# Pushbutton Change on Siemens Mk2 Nearside Signal, Demand & Wait Units

25th May 2018

**Product:** *Siemens Mk2 Nearside Equipment*

Figure 1: New Pushbutton Connections

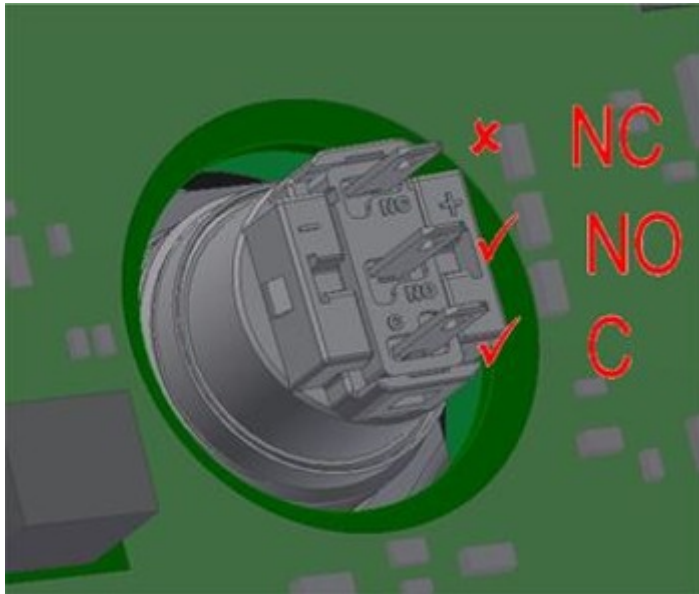
Please be aware that the connections on the new pushbutton are in different places and now have 3 tag terminals: Common (C), Normally Open (NO) and Normally Closed (NC). Figure 1 shows these 3 tag terminals.

**NOTE:** The Normally Closed (NC) tag, which is adjacent to the "+" & "-" symbols, should **never** be used.

Figure 2: New Pushbutton Connected

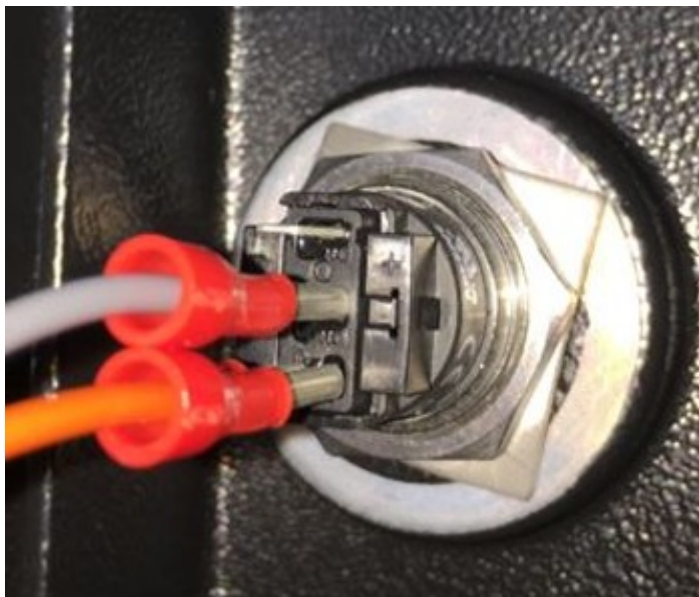
The cables to the new switch should now **only** be connected to the Common (C) and Normally Open (NC) tags (see Figure2).
